# Structural RAIs

Presentation to NRC  
June 18, 2009

# RAI 2-12 (cont.)

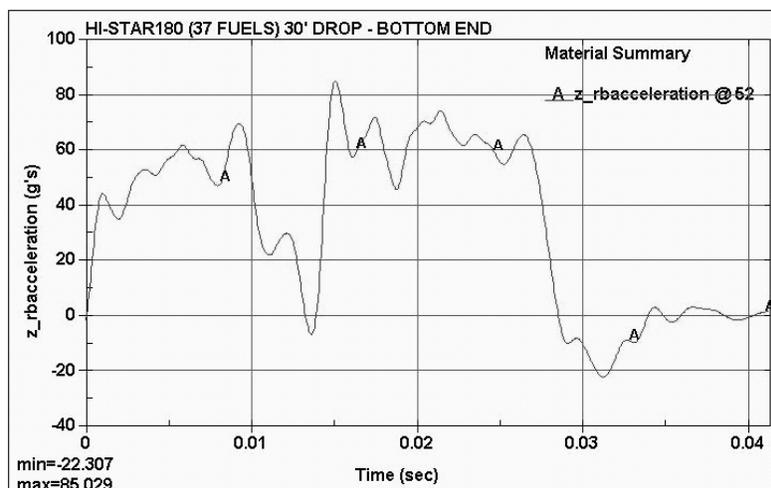
RAI: Justify the use of a limiting G load of 60 Gs when evaluating fuel performance during 9 meter bottom down fuel drop

Response: For the fuel rod integrity analysis, the impact limiter crush force is set based on the initial impact between the HI-STAR 180 package and the ground (i.e., before the gap between the fuel assemblies and Fuel Impact Attenuators (FIA) closes) as determined by LS-DYNA.

Response (cont.): The peak cask deceleration of 85 G predicted by LS-DYNA occurs after the fuel assemblies have impacted the FIA assemblies and have started to rebound. By that time, the most severe loading on the fuel pins has already occurred. Since the single fuel pin model explicitly includes the FIA spring and the 20 mm maximum clearance gap between the fuel assembly and the FIA, it is appropriate to set the impact limiter crush force based on the initial impact with the ground.
